SHOP DRAWING SUBMISSION FORM

Project	Proposed Residential Development at N.K.I.L. No. 6552, Kai Tak Area 4C, Site 2, Kai Tak, Kowloon
Works	Main Contract
Contract No.	19098KL
Ref. No.	19098KL / SS / AR - 004 / GC (Rev. 4)
Date	**06-Dec-2021**
To / Attn	Ronald Lu & Partners (Hong Kong) Ltd. / **Mr. Kelvin Ip/ Mr. Frederick Chan/ Ms. Magenta Kietkhajornsiri**
Subject	**Shop Drawing Submission of Curtain Wall (Tower)**
Anticipated date of response	**13-Dec-2021**

RESPONSE TO SHOP DRAWING SUBMISSION

01/1001 TOWER 1, 2 AND 3 TYPICAL FLOOR FRAMING PLAN FOR CURTAIN WALL(2/F - 32/F PLAN 27 STOREYS)

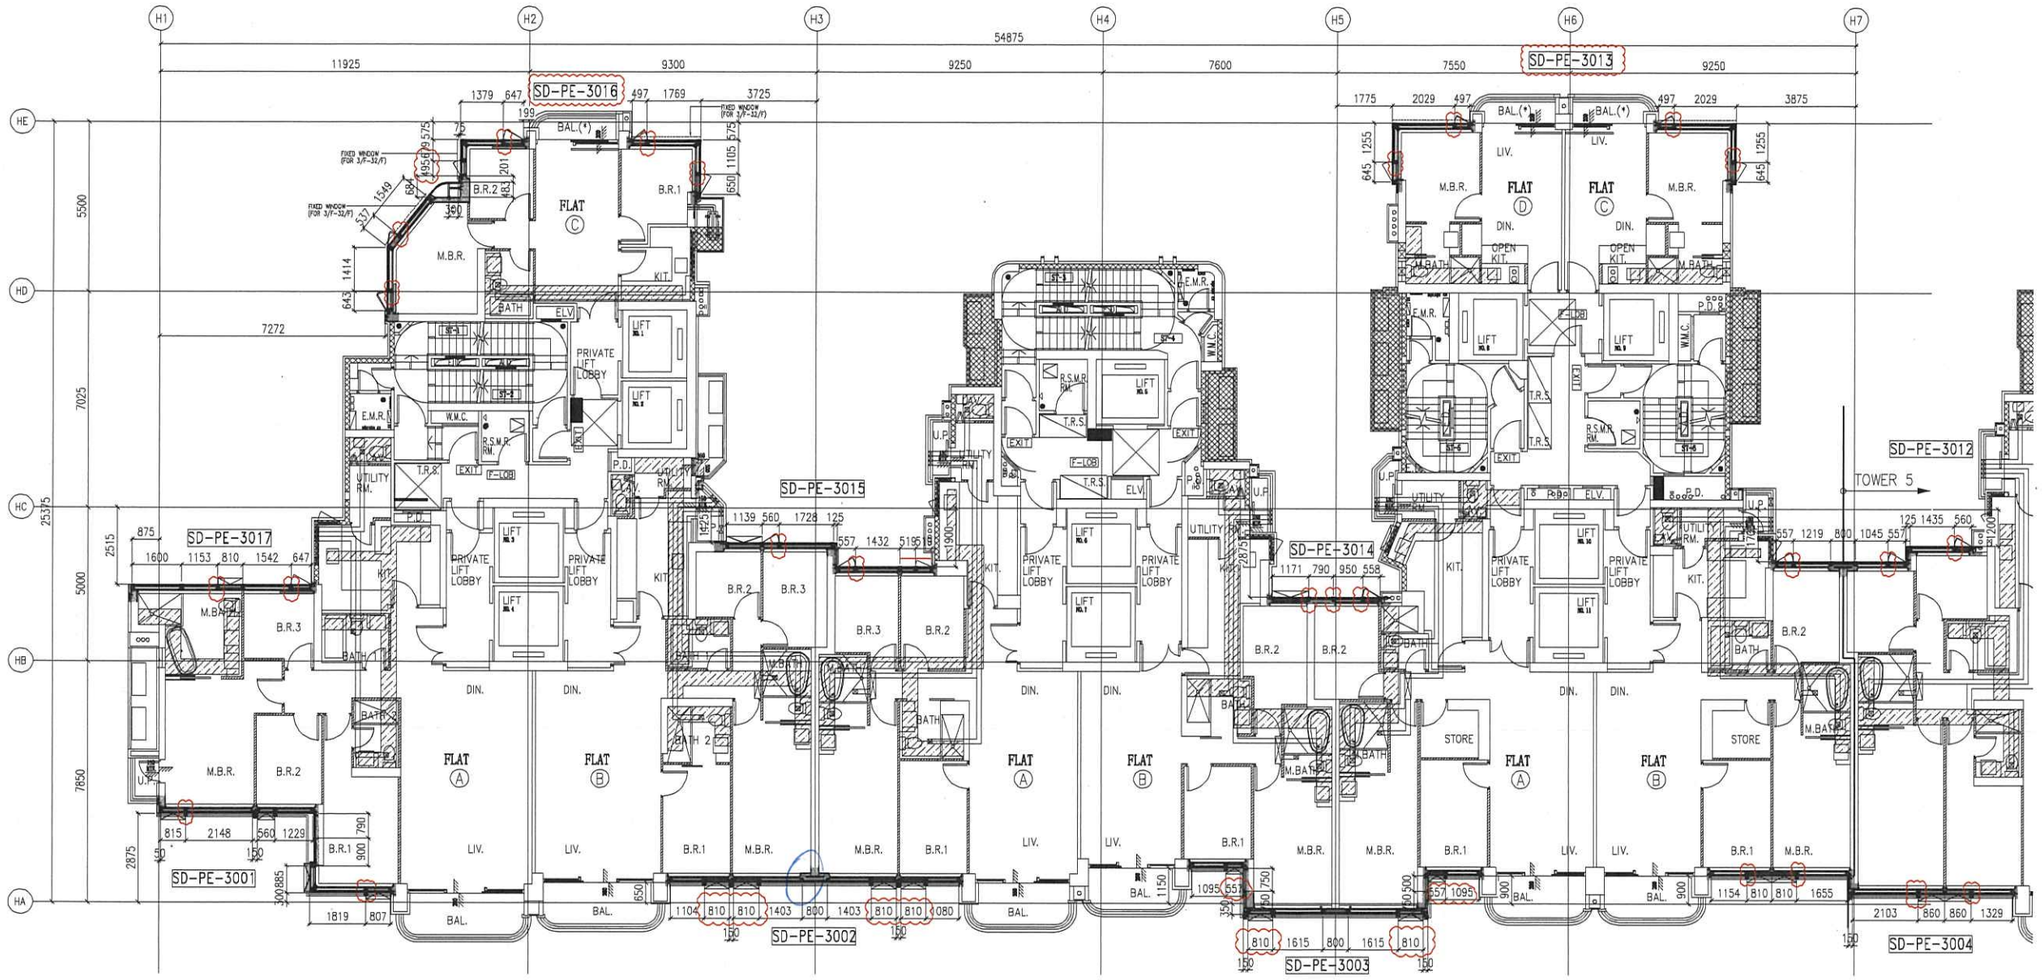
5) Interfacing details between **external pipe ducts** and curtain wall subject to coordination with Far East. (Drawing no. **DT-4016**). Reference is also made to tender drawing no. **INH-EWS1-009.**

TOWER 1, 2 AND 3 TYPICAL FLOOR FOR CURTAIN WALL PLAN

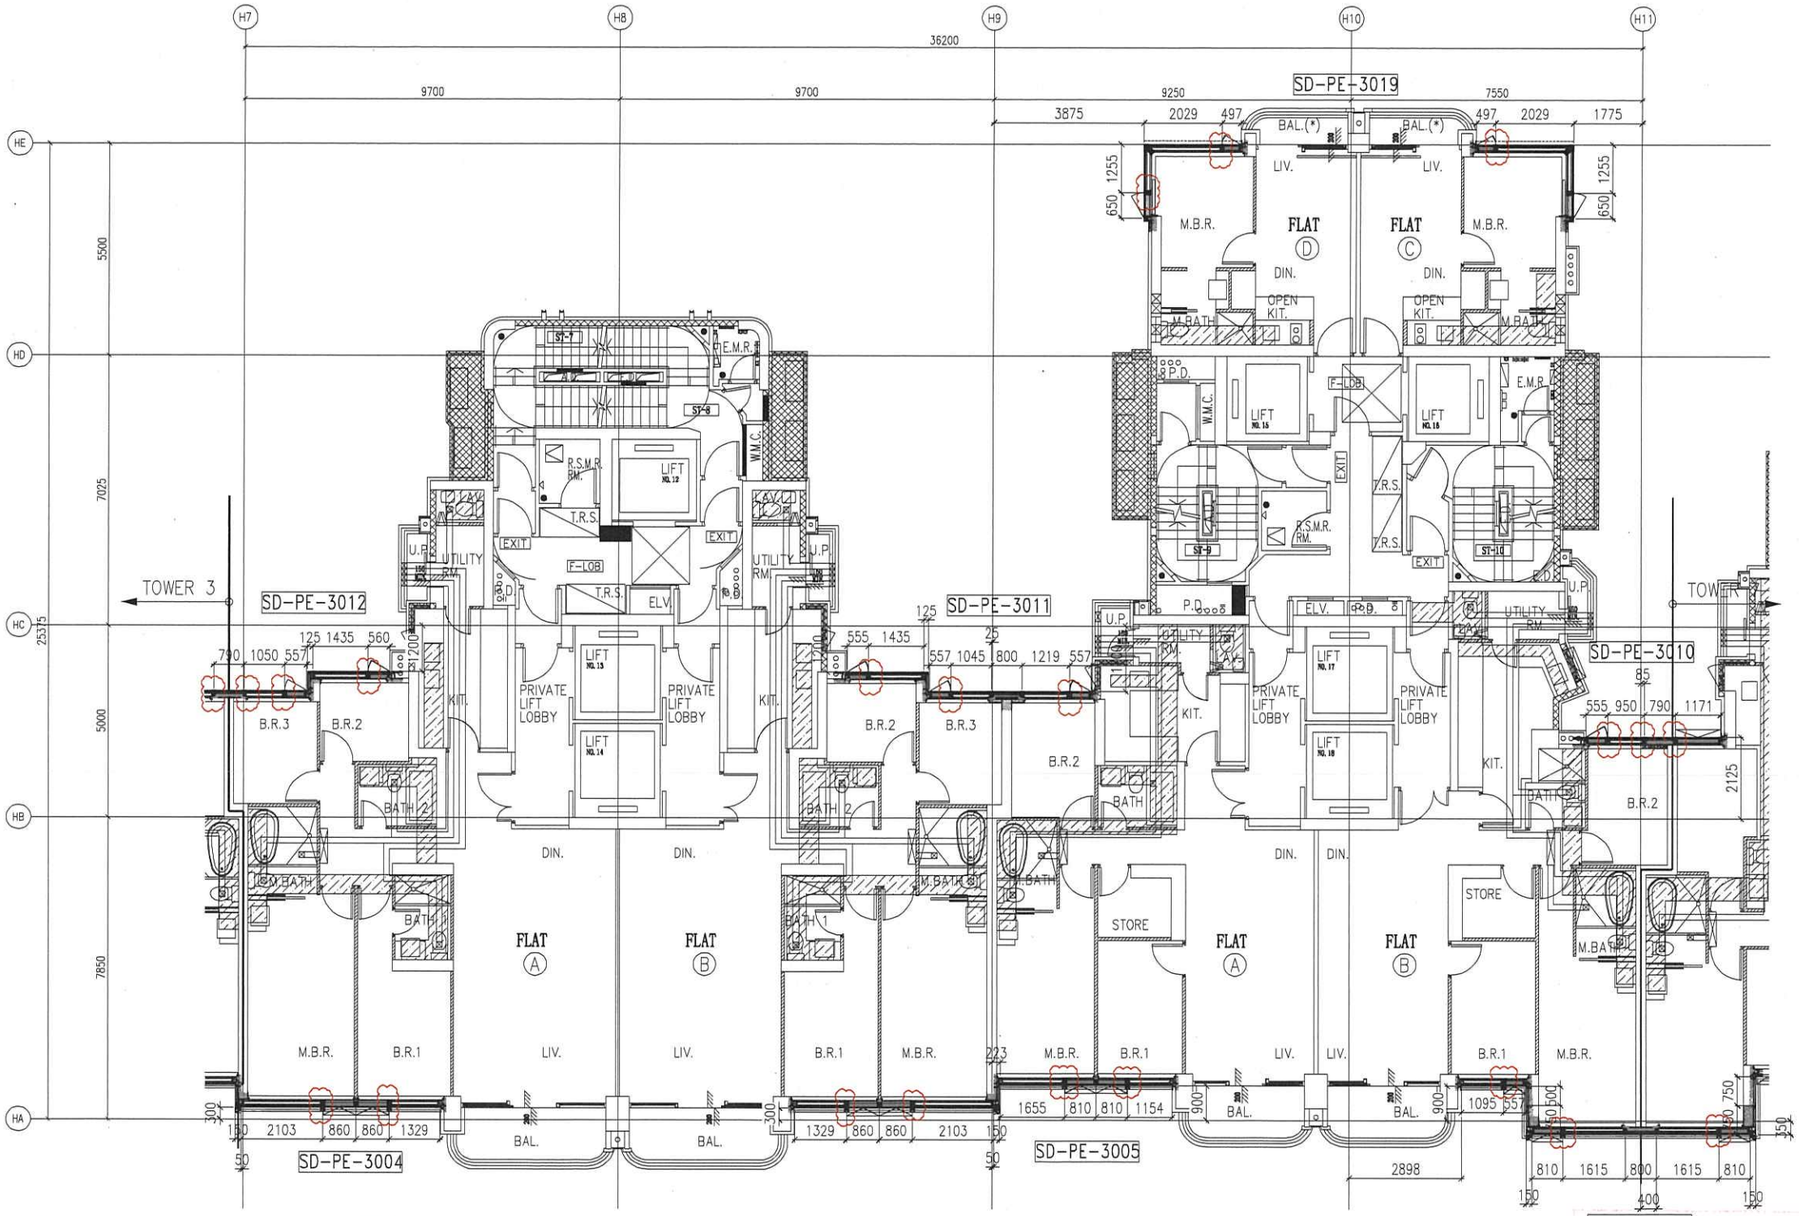
* follow comments on partial plans for modification

TOWER 5 AND 6 TYPICAL FLOOR FOR CURTAIN WALL PLAN

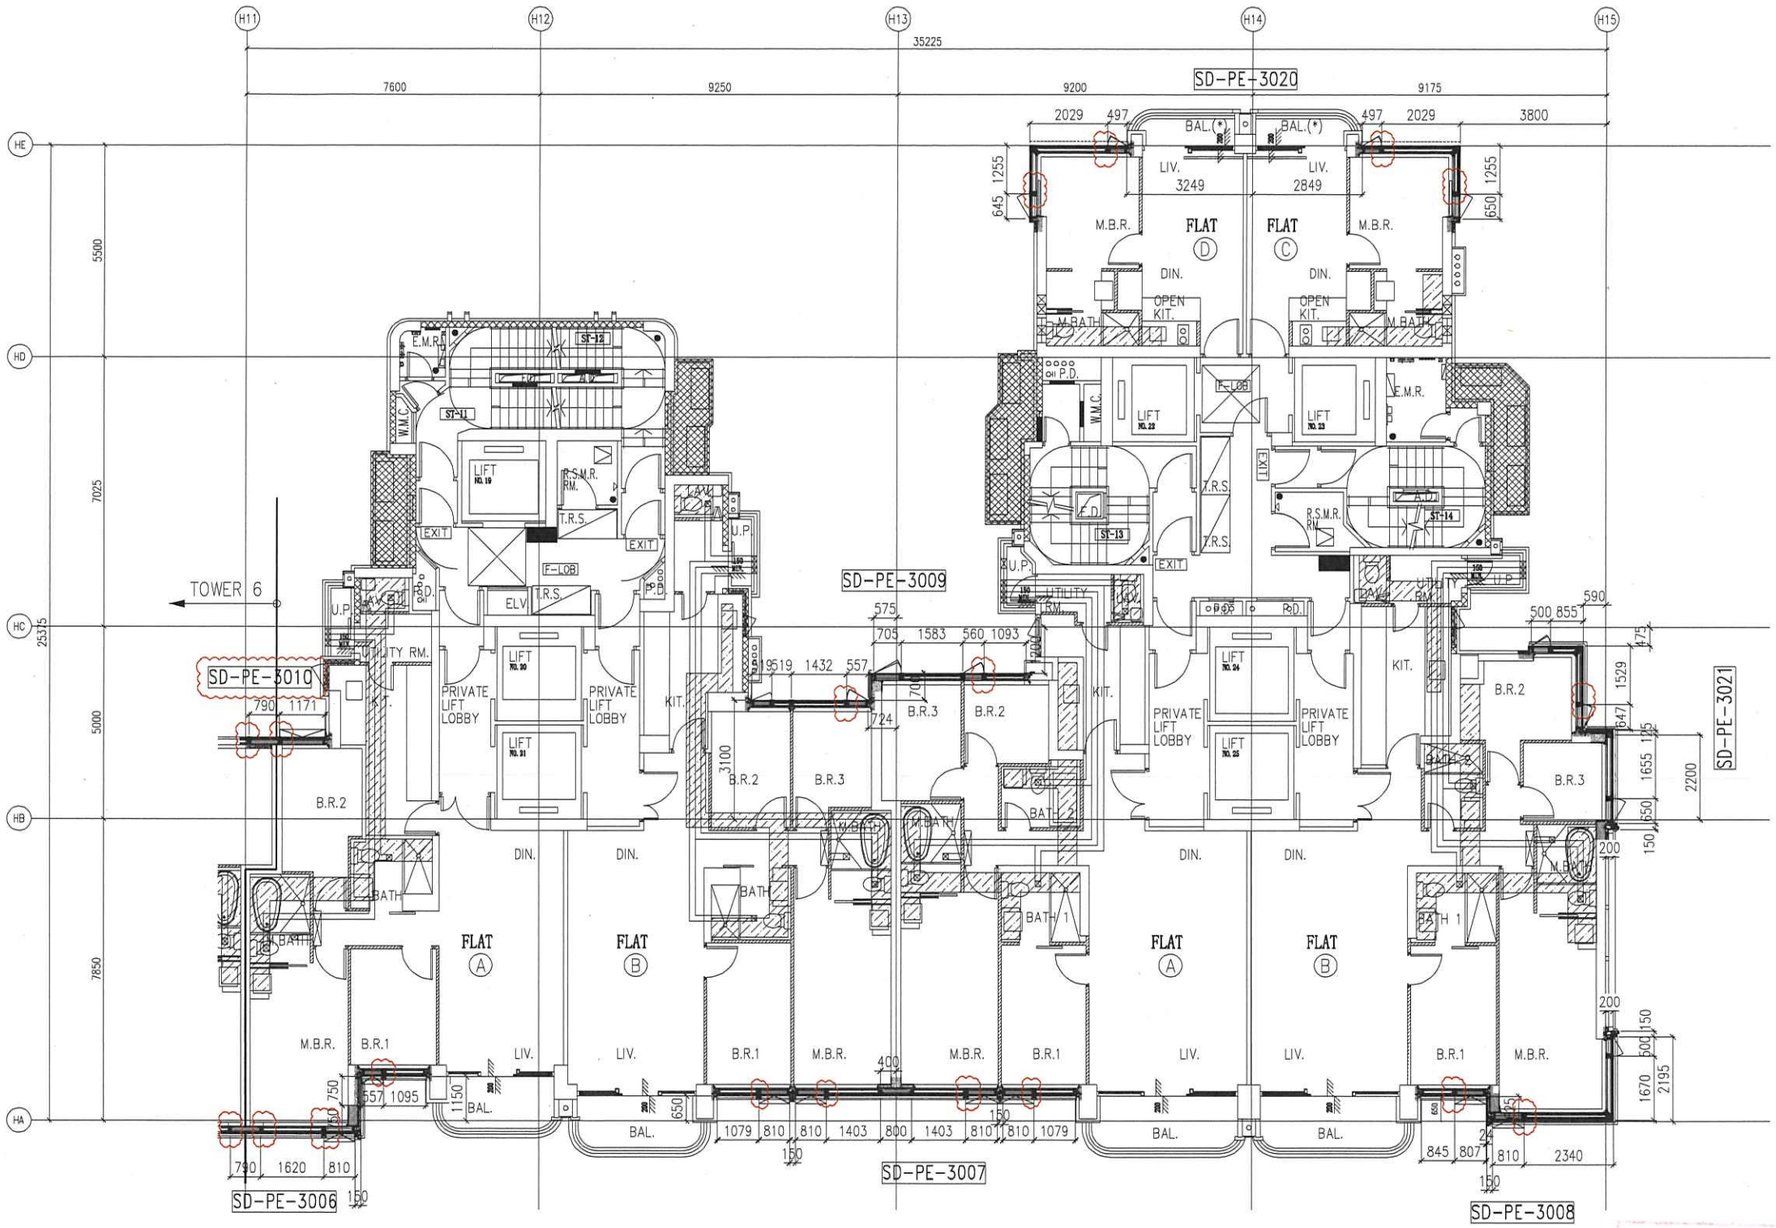
A FOLLOW COMMENTS ON PARTIAL PLANS FOR MODIFICATION.

TITLE :
TOWER 7 AND 8 TYPICAL FLOOR FOR CURTAIN WALL PLAN

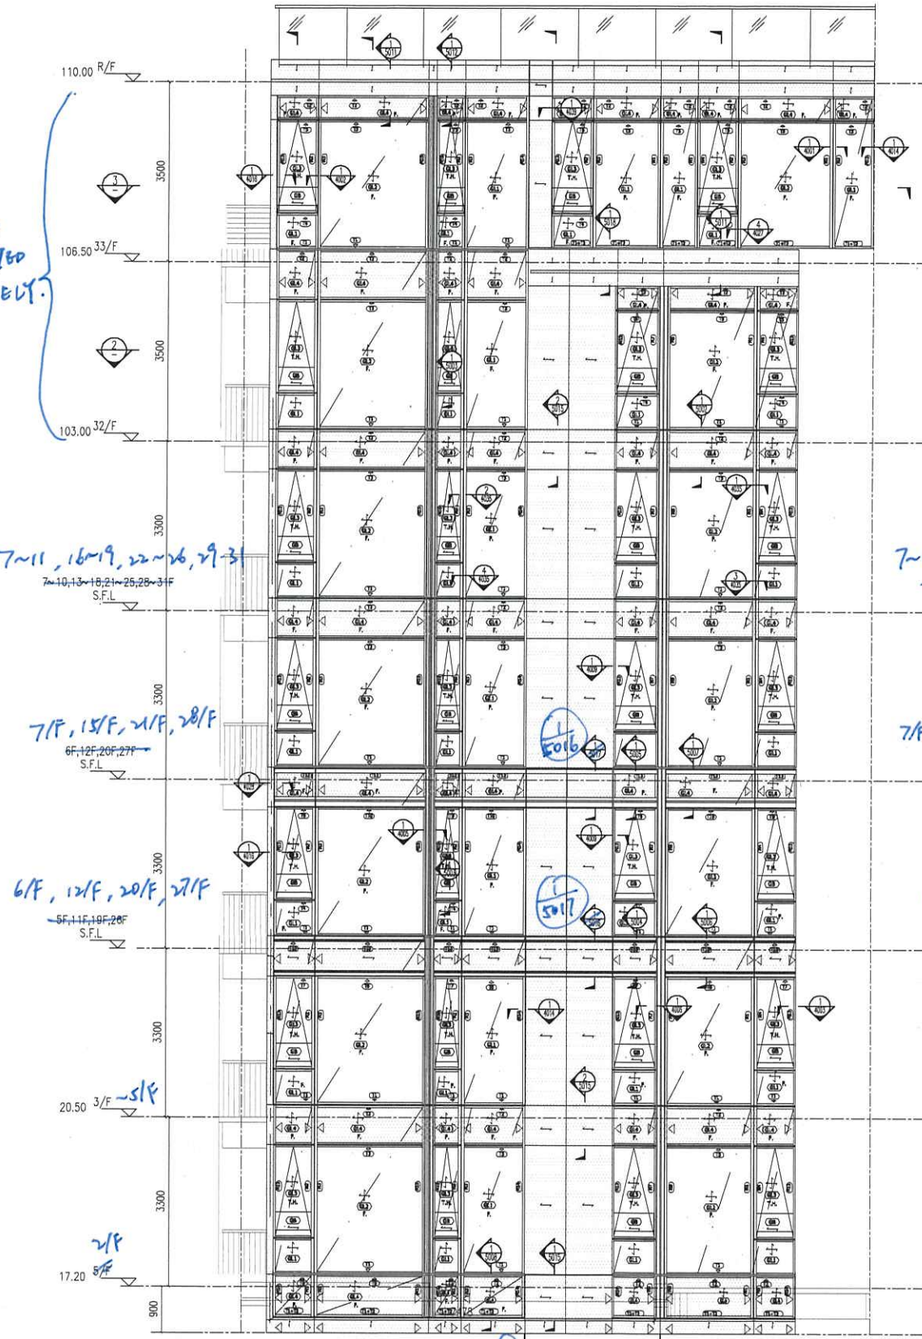
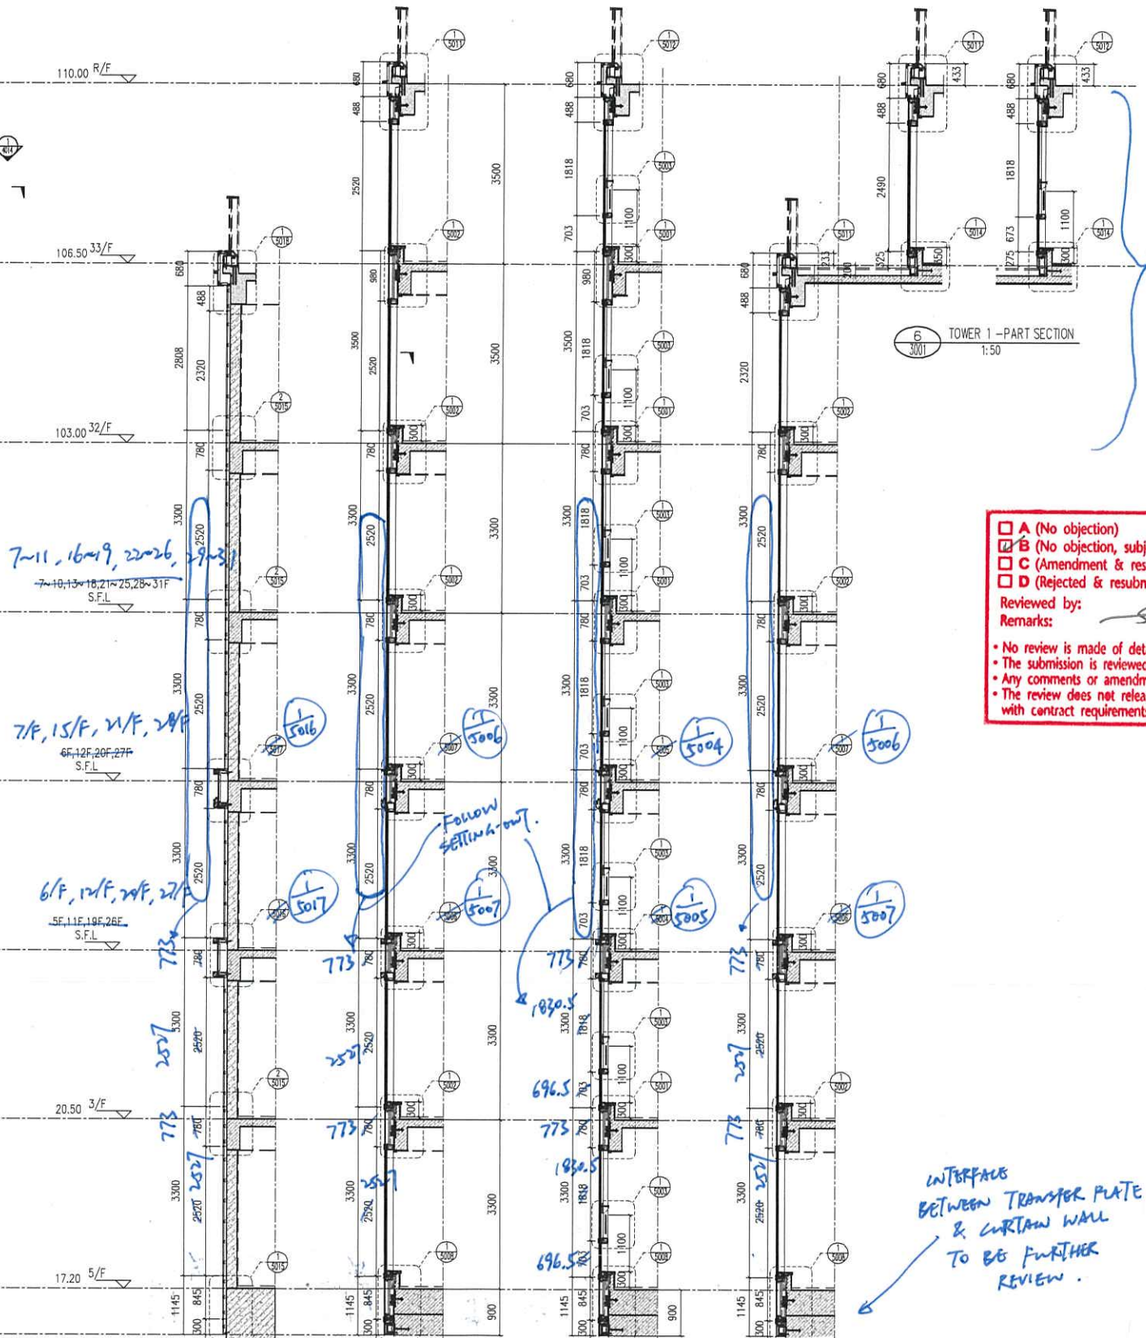
A FOLLOW COMMENTS ON PARTIAL PLANS FOR MODIFICATION.

1 3006 TOWER 6&7 –PART ELEVATION 1:50

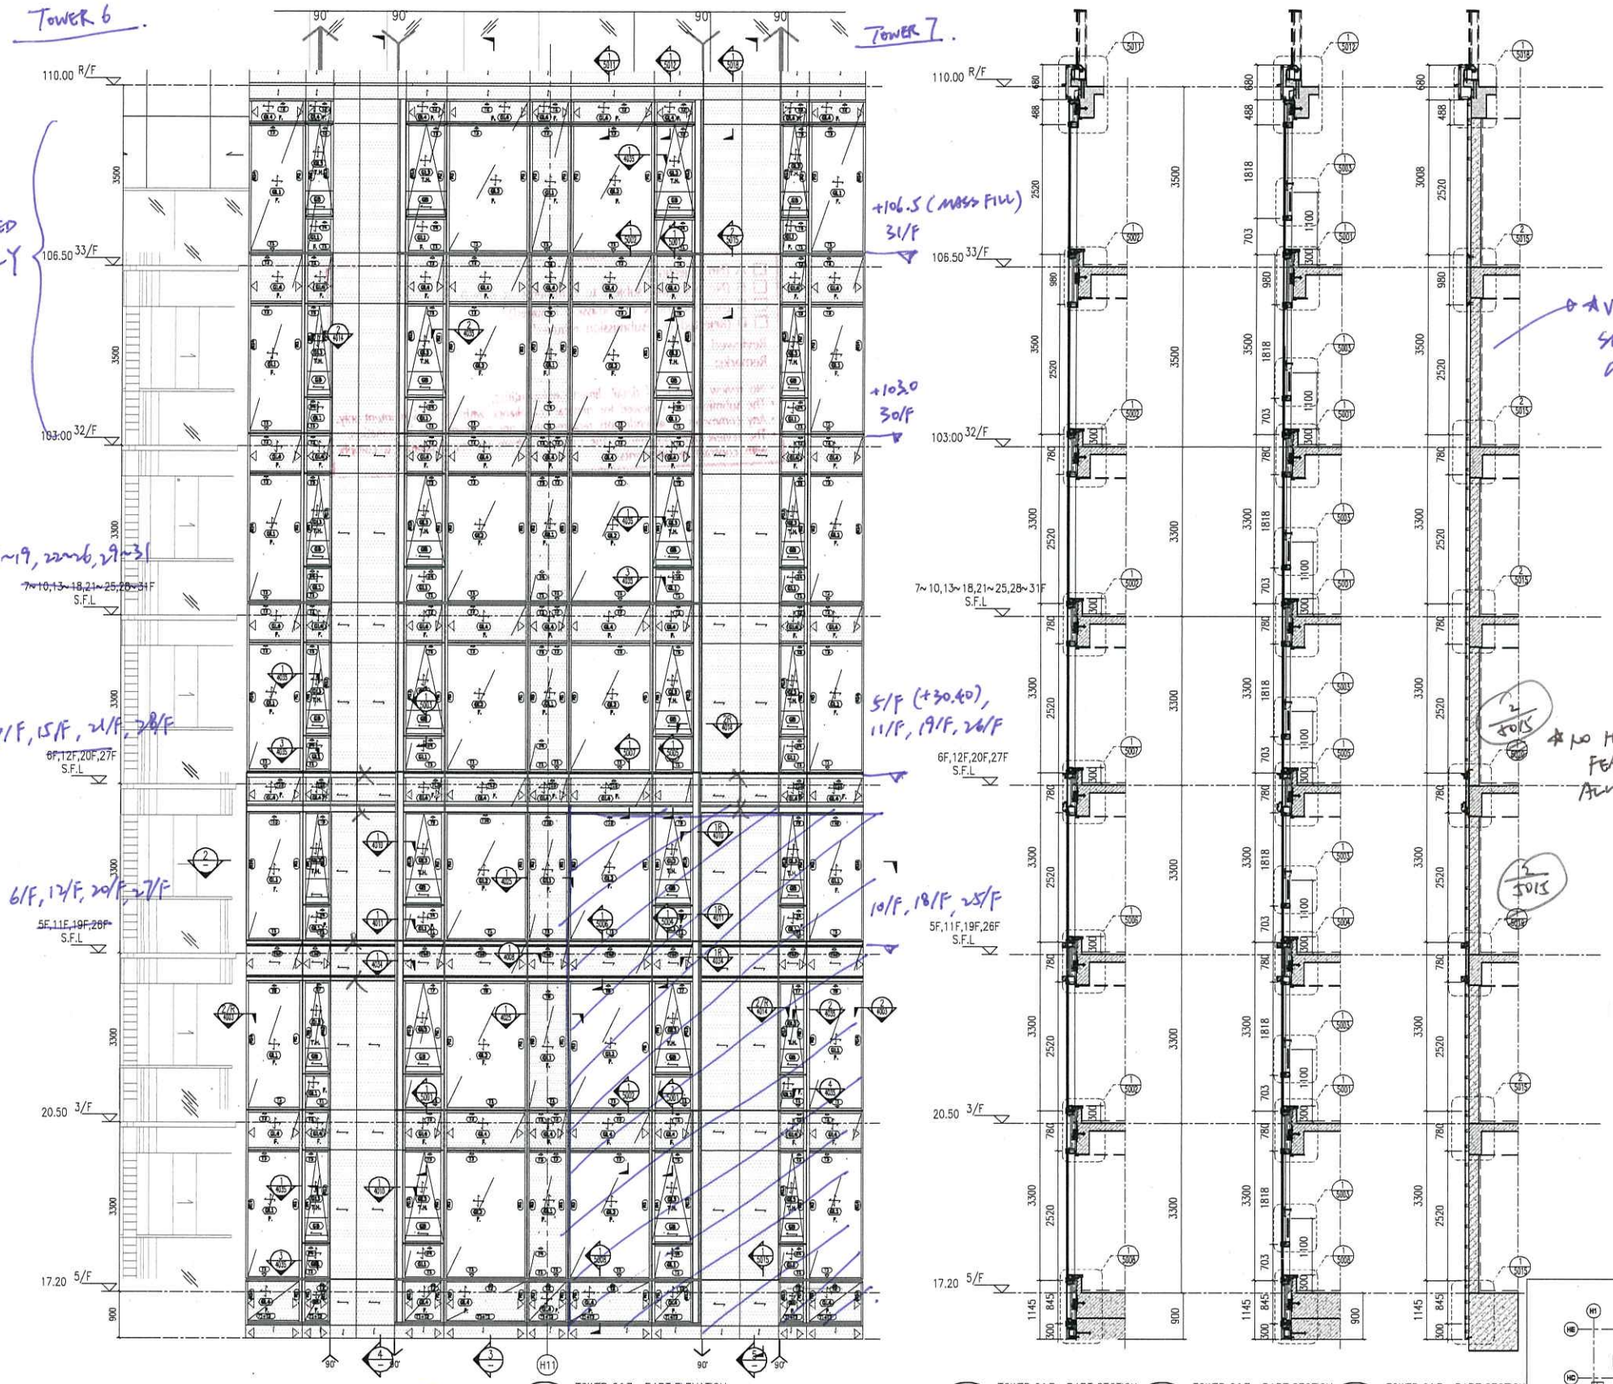
* ADD SECTIONS FOR TOWER 7.

* MODULATION FOR GLASS PANES BETWEEN T6 AND T7 REFERS TO PODIUM PLANS (A2-AR-008)
